REFERENCE: C.N.227.1997.TREATIES-44 (Notification dépositaire)

PROCES-VERBAL CONCERNING CERTAIN
MODIFICATIONS TO REGULATION NO. 44
ANNEXED TO THE AGREEMENT

WHEREAS the Administrative Committee
of the above Agreement at its fifth
session, adopted certain drafting
modifications to Regulation No. 44
("Uniform provisions concerning the
approval of restraining devices for
child occupants of power-driven vehicles
("child restraint system")
(TRANS/WP.29/560),

Figure 1:
Arrangement for testing a forward-facing device

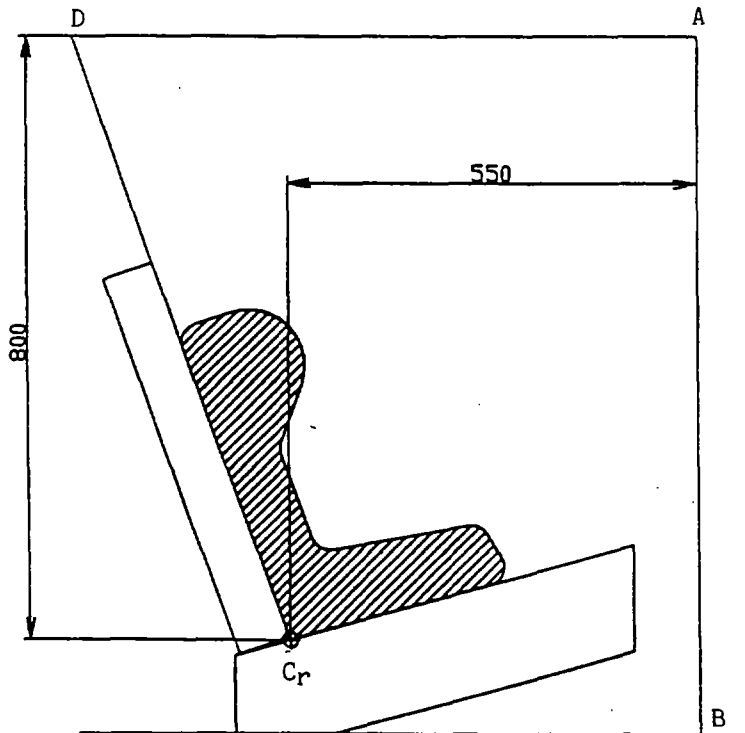
Paragraph 7.1.4.4.1.1., delete the words "groups I, II and III" and figure 1 replace by the following new figure 1:

Figure 2:

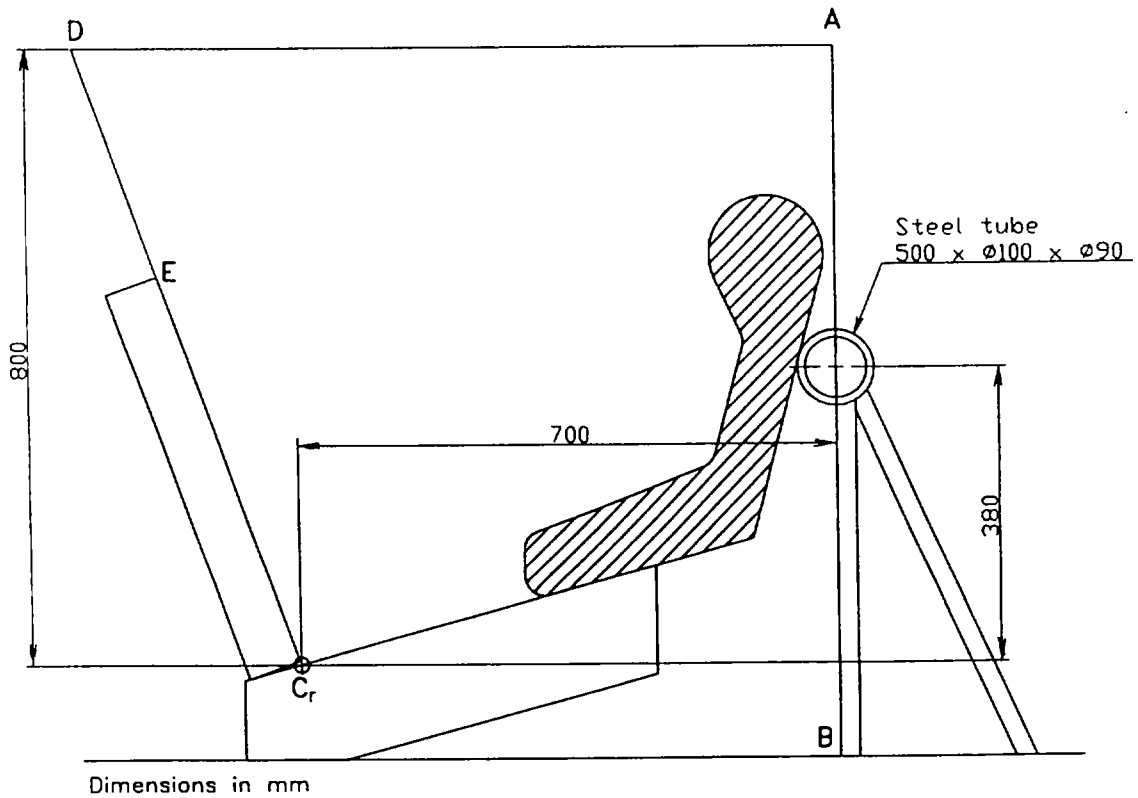
Paragraph 7.1.4.4.1.2.1. Figure 2, replace by the following new figure 2:

Figure 3:

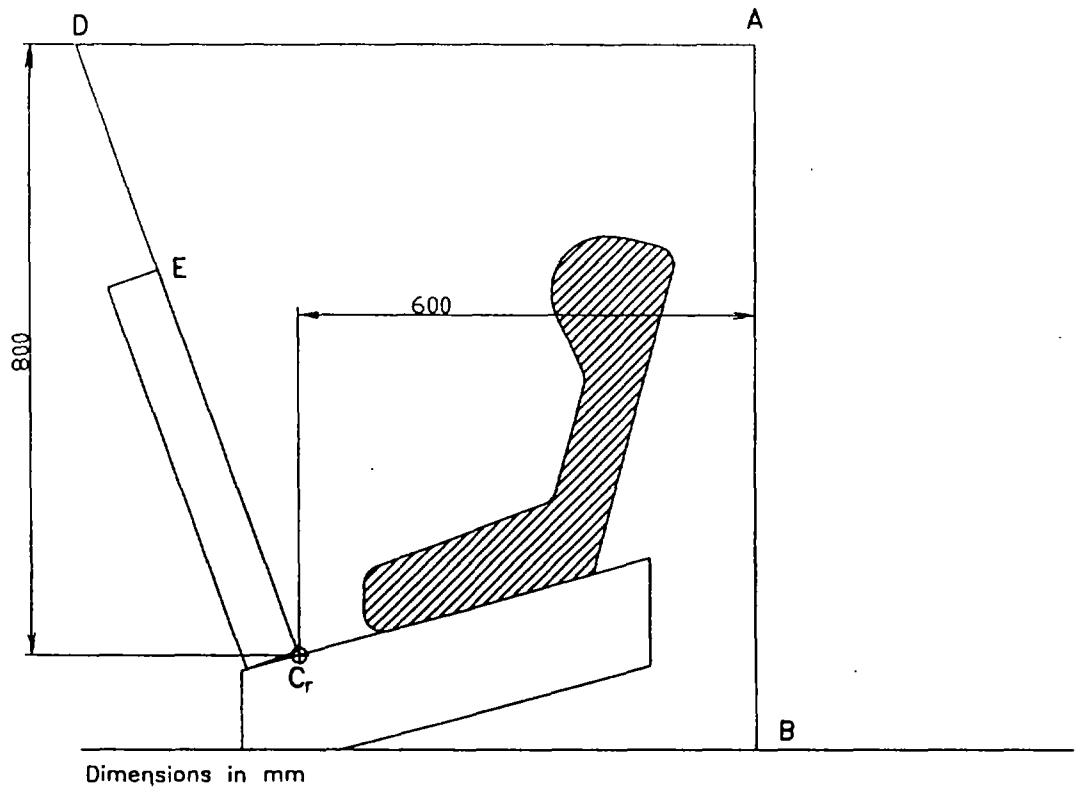
Paragraph 7.1.4.4.1.2.2., Figure 3, replace by the following new figure 3:

Figure 4:

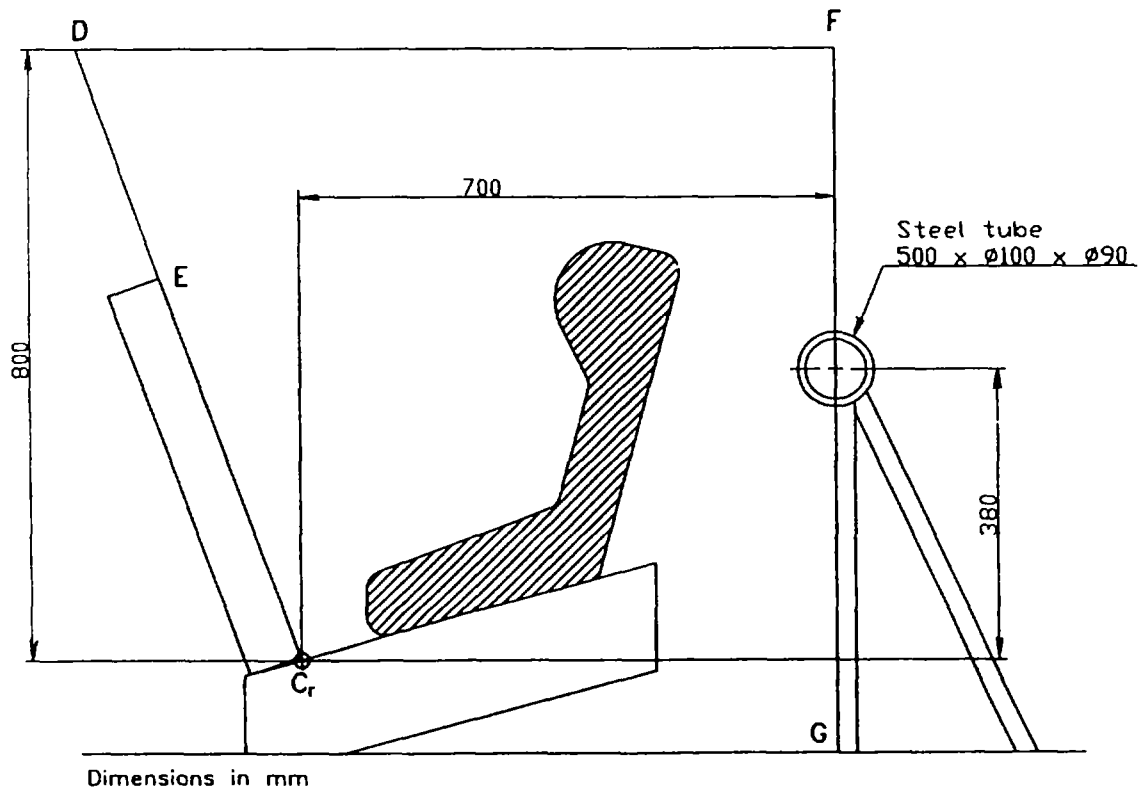
Paragraph 7.1.4.4.1.2.3., amend to read (inserting also a new Figure 4):

"7.1.4.4.1.2.3. Child restraints other than group O not supported by the dashboard:

The head of the manikin shall not pass the planes FD, FG and DE, as shown in Figure 4 below.

In the case that the load transfer devices connecting the child restraint with the adult belt are liable to break or detach and if there is contact of such a child restraint with the 100 mm diameter bar, there shall be one further dynamic test (front impact) with the heaviest dummy intended for such child restraint and without the 100 mm diameter bar; the only requirement for this test is that the above mentioned load transfer devices shall not break or detach.

Figure 1:
Arrangement for testing a rearward-facing device

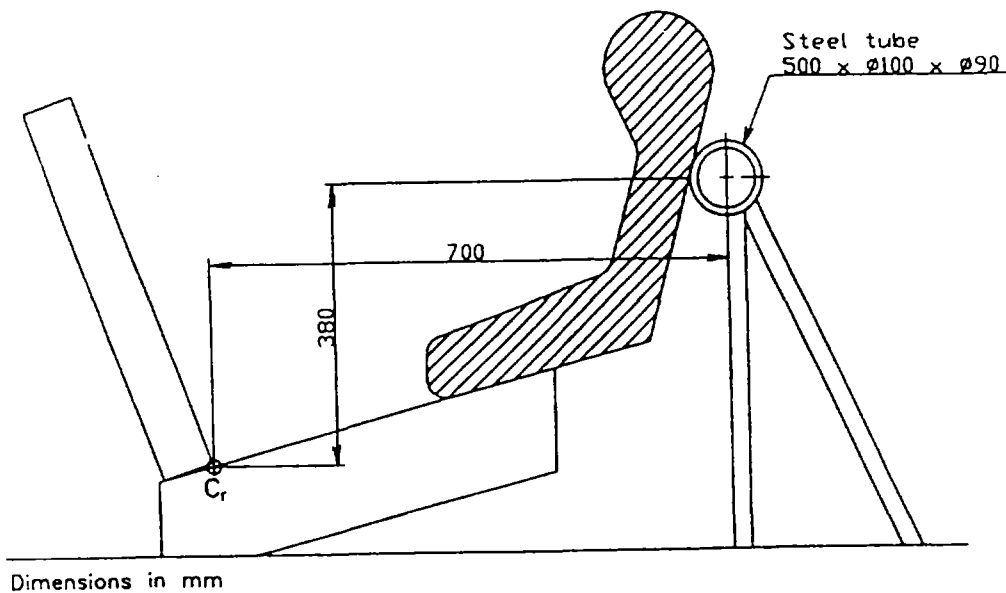
Paragraph 3.2.3., Figure 1, replace by the following new figure 1:

Figure 1:
Dimensions of the seat and the seat cushions

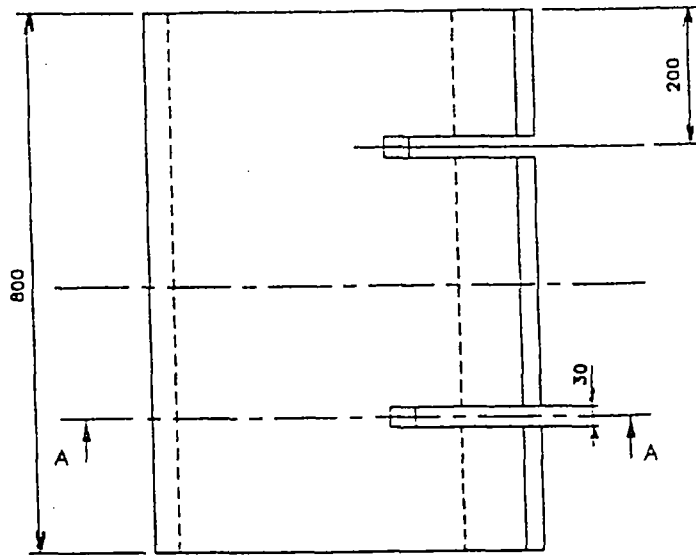
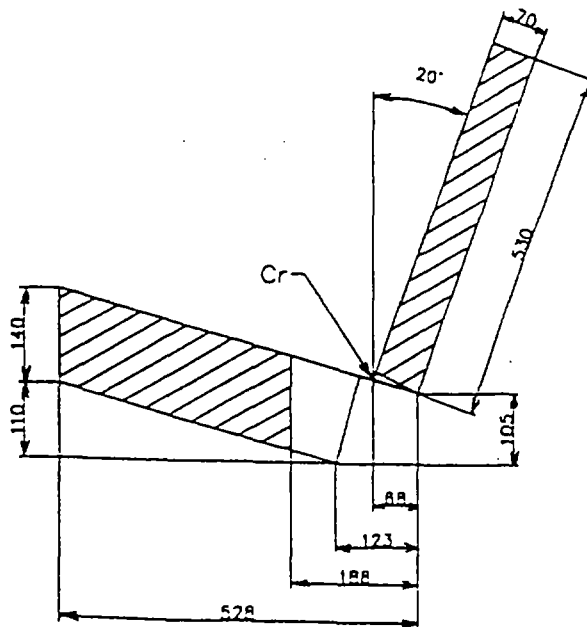
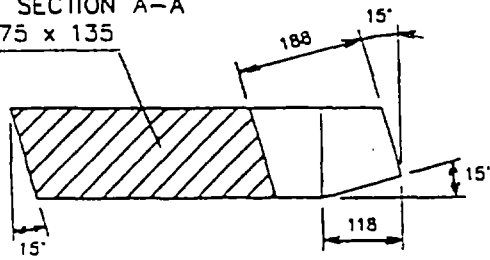
Annex 6-Appendix 1, Figure 1, replace by the following new Figure 1:

Figure 3:
Dimensions of the cover material

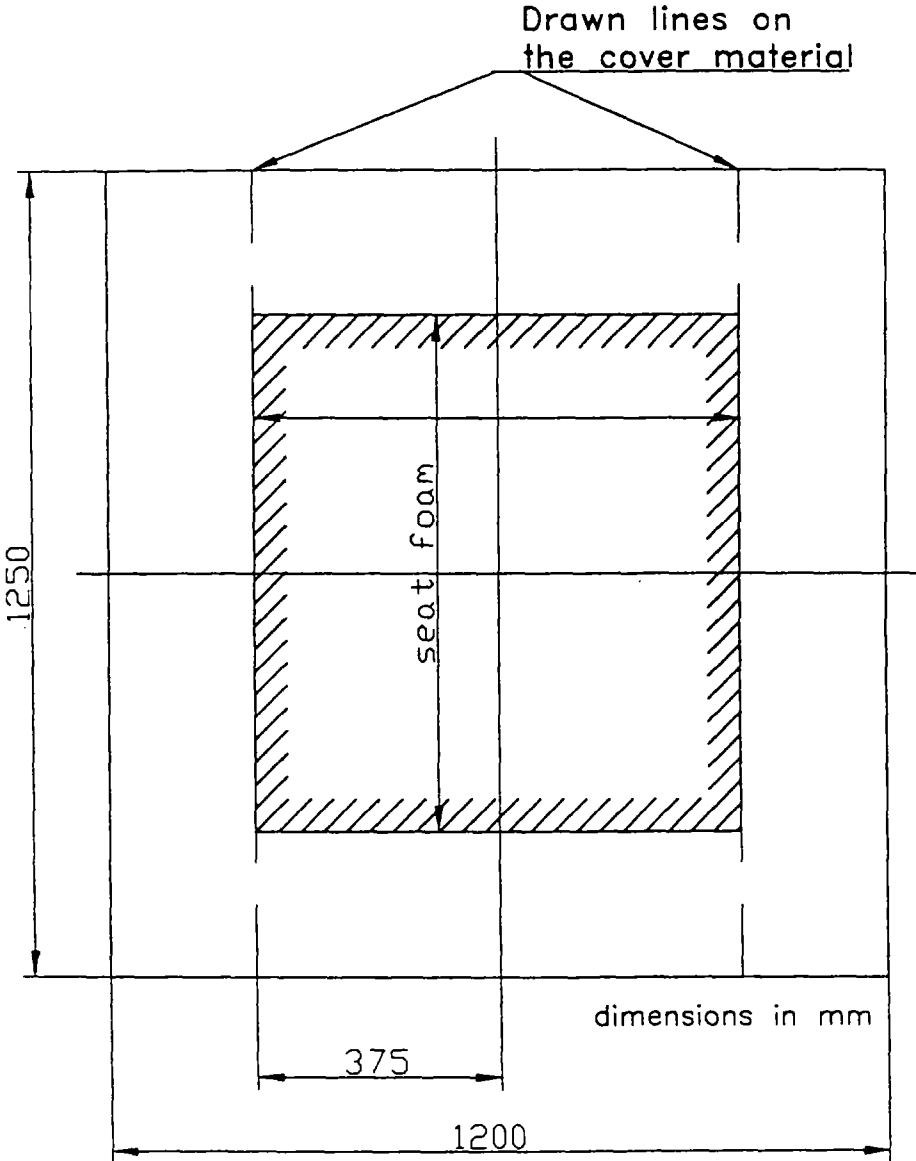
Annex 6-Appendix 1, Figure 3, replace by the new following figure 3:
